*BEACON PLANNING BOARD*  
*One Municipal Plaza - Courtroom*  
*BEACON, NEW YORK 12508*  
*Phone (845) 838-5002 Fax (845) 838-5026*

The Planning Board will meet on **Tuesday, June 12, 2018** in the Municipal Center Courtroom. A work session will take place at 7:00 PM for a training workshop, discussion of agenda items and/or topics of interest to the Planning Board. The regular meeting will begin immediately thereafter, but not later than 7:30 p.m.

Re: 25 Townsend Street Subdivision  
Tax ID 6055-03-383149 (±5.0 acres)  
City of Beacon, New York

On behalf of the Applicant for the above referenced project, Hudson Land Design (HLD) has enclosed five (5) revised plan sets (8 sheets) and one (1) electronic version of the plans (along with this response letter) based on comments received from the Planning Board and its consultants. We offer the following responses to each comment from your consultants:

DATED: MAY 22, 2018  
SCALE: 1" = 20'-0"  
DRAWING:  
**5 OF 9**

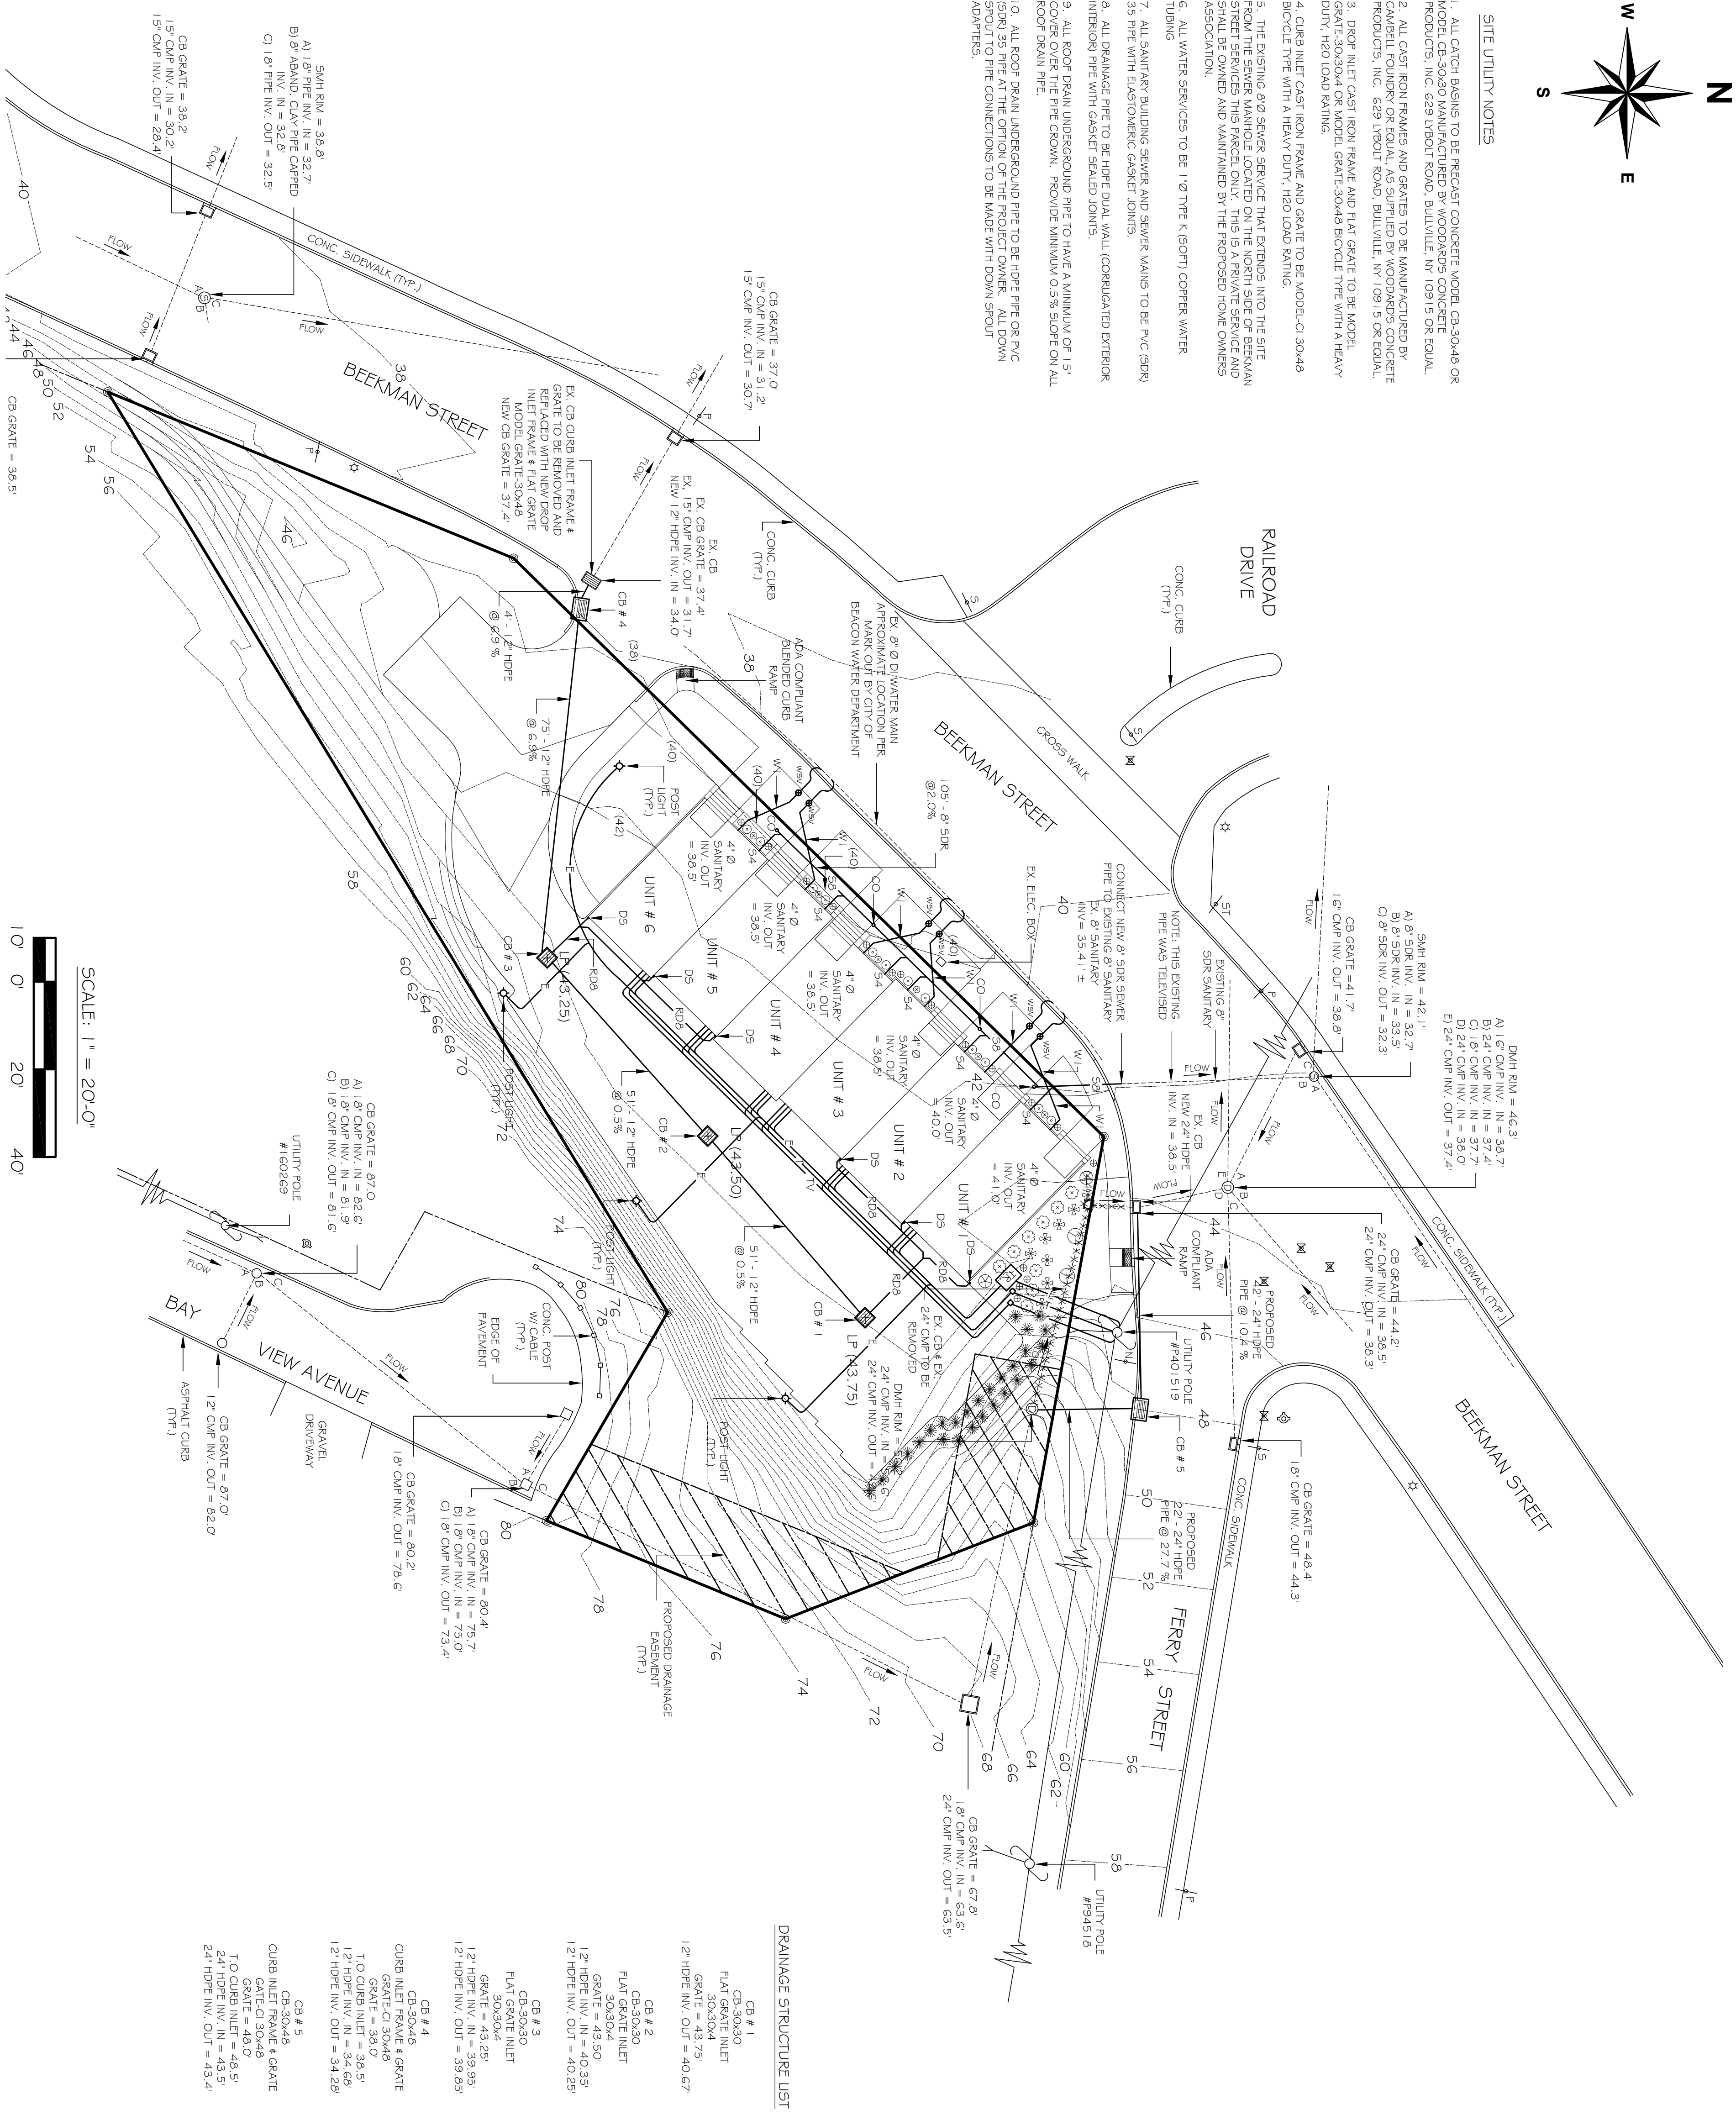
Sheet 5 of 9 (Site Utility Plan):

1. An additional catch basin has been added to the south side of the entrance as indicated on the Site Utility Plan (drawing 5 of 9) provided in this submission.
2. The installation of ADA compliant ramps at either end of the sidewalk have been noted on the Site Utility Plan (drawing 5 of 9) provided in this submission.

3. The existing 8" sewer service that extends into the site from the sewer manhole on the north side of Beekman Street has been noted as private service and shall be owned and maintained by the HOA as indicated in Note # 5 (Site Utility Notes) on the Site Utility Plan (drawing 5 of 9) provided in this submission.
4. The 8" sewer service has been revised to extend straight to a point between units 1 and 2, and then a bend put on the line to redirect the line along the front of the building as indicated on the Site Utility Plan (drawing 5 of 9) provided in this submission.
5. Unit #2 has been noted as such on the Site Utility Plan (drawing 5 of 9) provided in this submission.
6. A catch basin, in lieu of the manhole, has been indicated along the curb line on Ferry Street as indicated on the Site Utility Plan (drawing 5 of 9) provided in this submission.

SIGHT DISTANCE TABLE			NOTE
S1SD RIGHT	REQUIRED 335	PROVIDED 367±	(A)
S5D	REQUIRED 200	PROVIDED 500±	(B)
T5D	REQUIRED 245	PROVIDED 500±	(C)
S1SD LEFT	REQUIRED 290	PROVIDED 303±	(D)

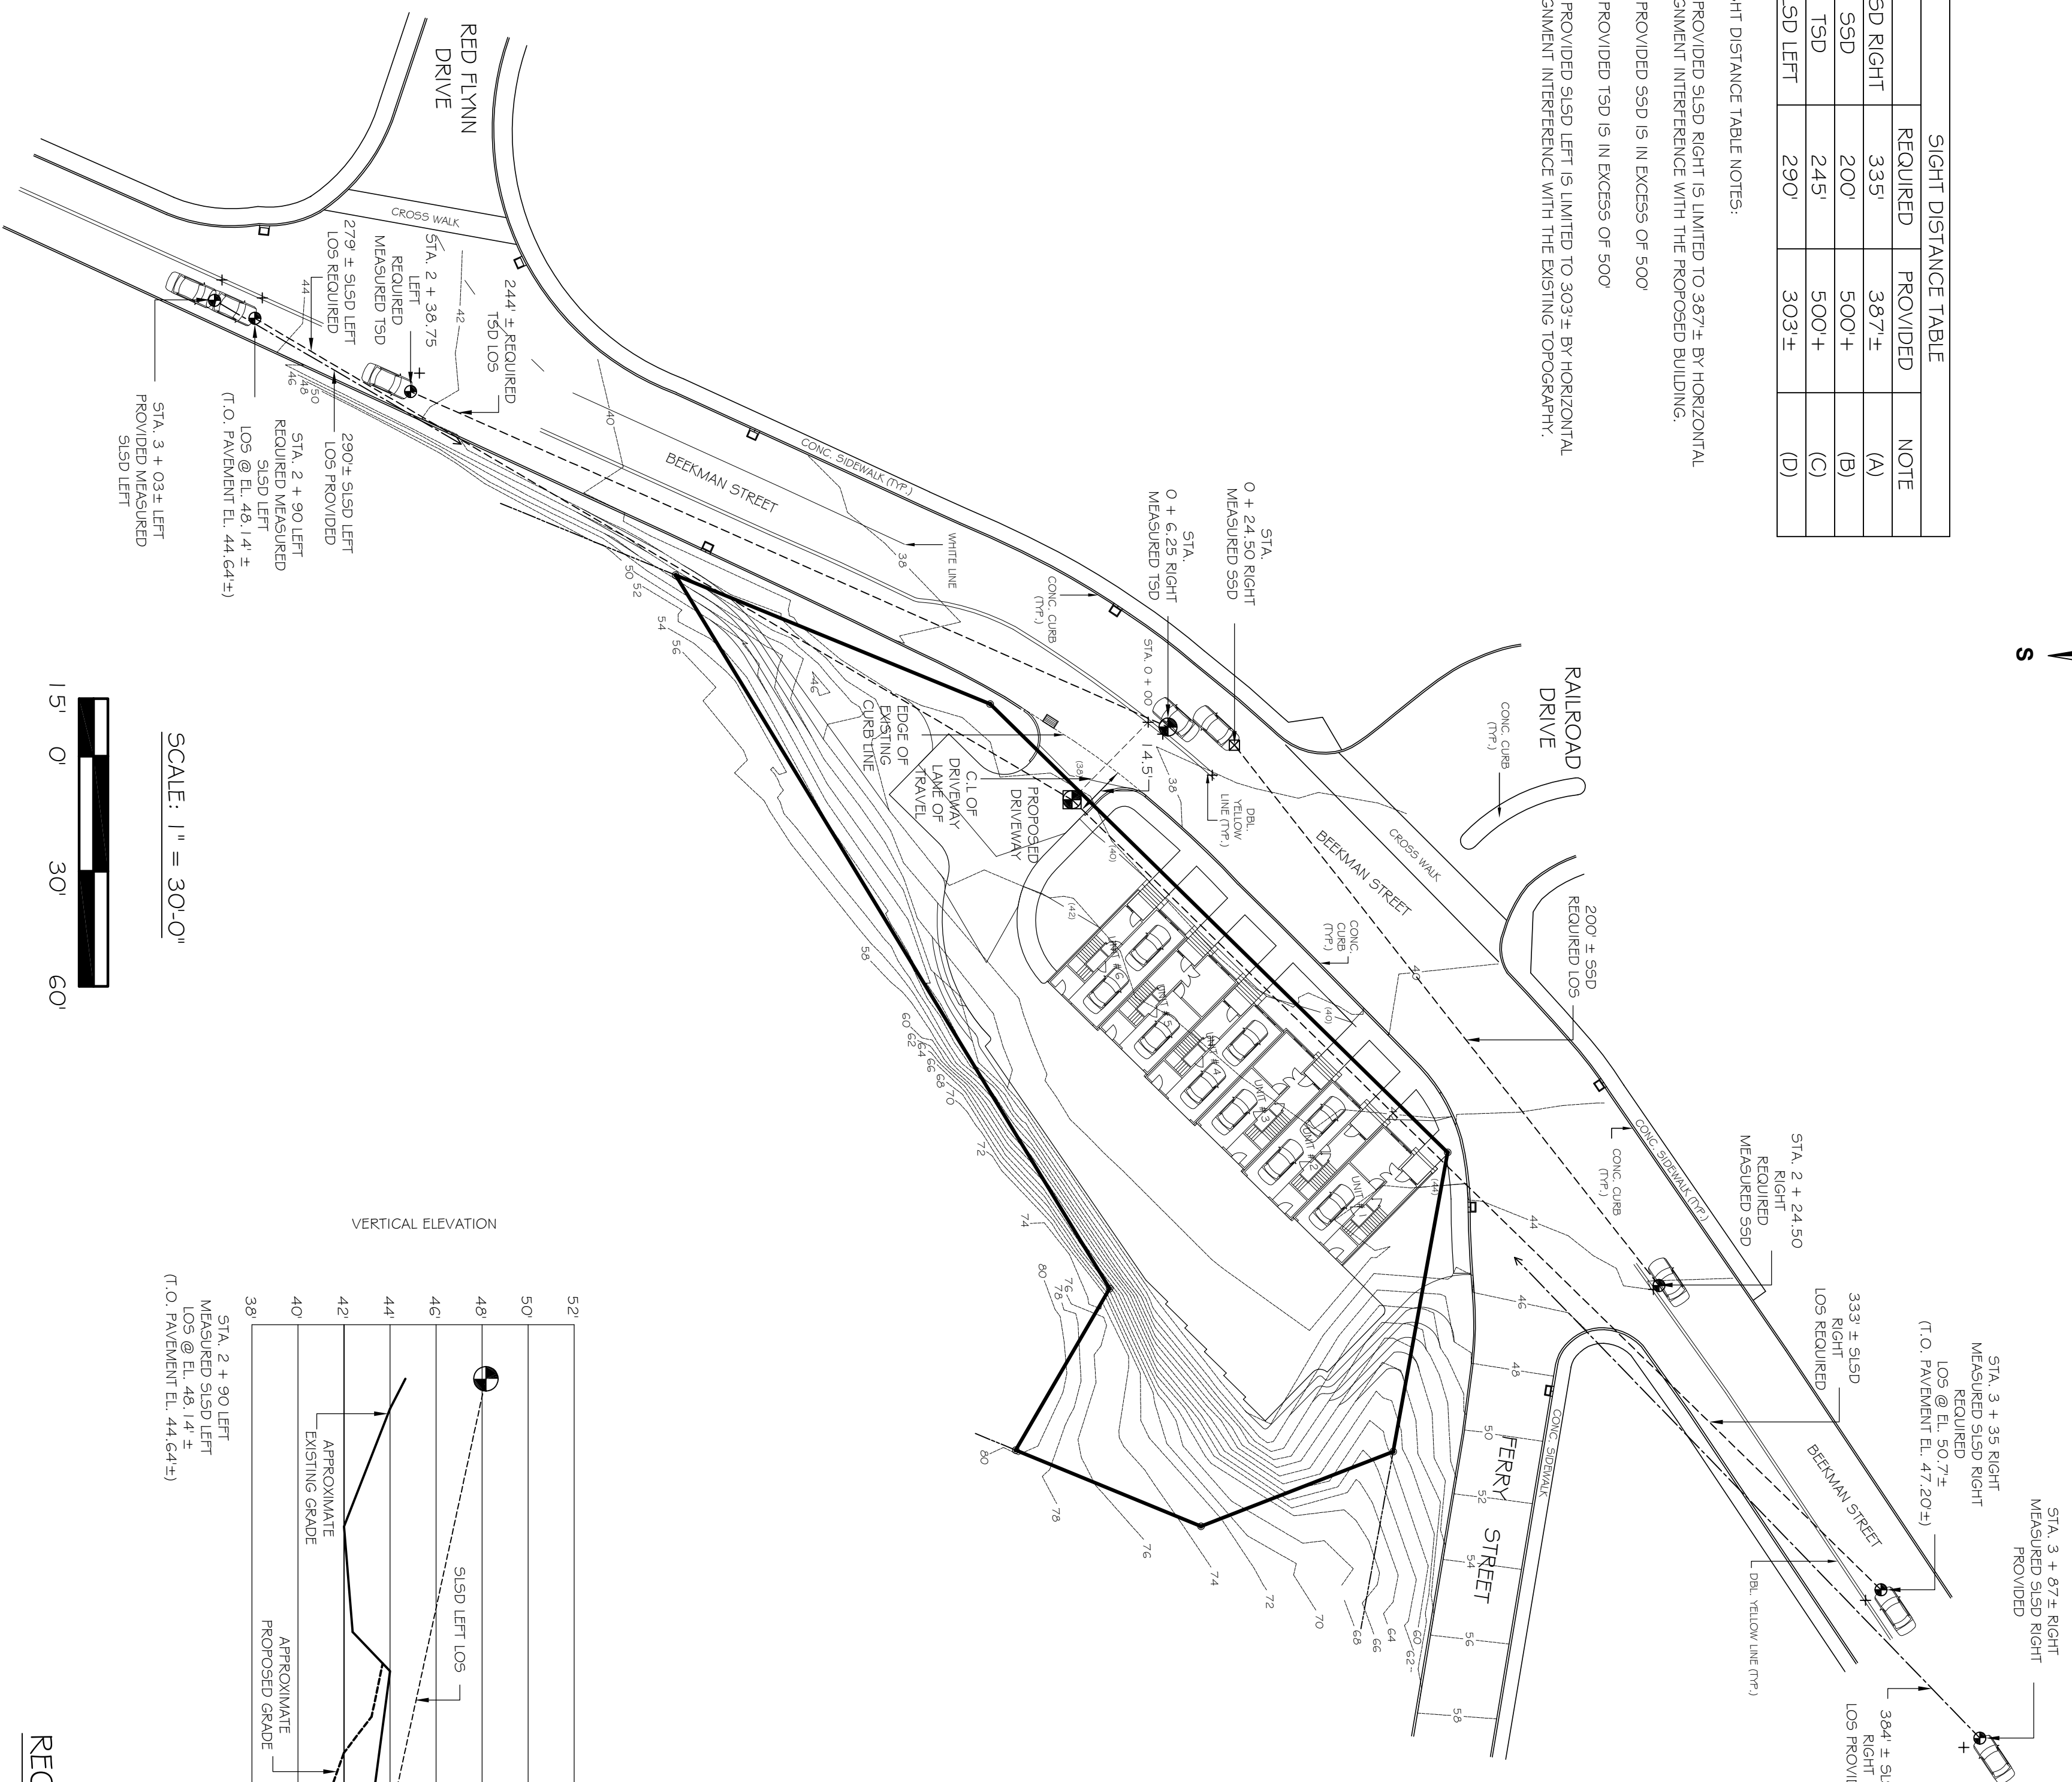
Sheet 7 of 9 (Site Distance Plan):

1. The sight distances have been labeled on all lines as indicated on the Sight Distance Plan (drawing 7 of 9) provided in this submission.
2. A "Sight Distance Table" has been provided on the Sight Distance Plan (drawing 7 of 9) provided in this submission.
3. Sight distance measurements for actual sight distances achieved have been provided on the Sight Distance Plan (drawing 7 of 9) provided in this submission.
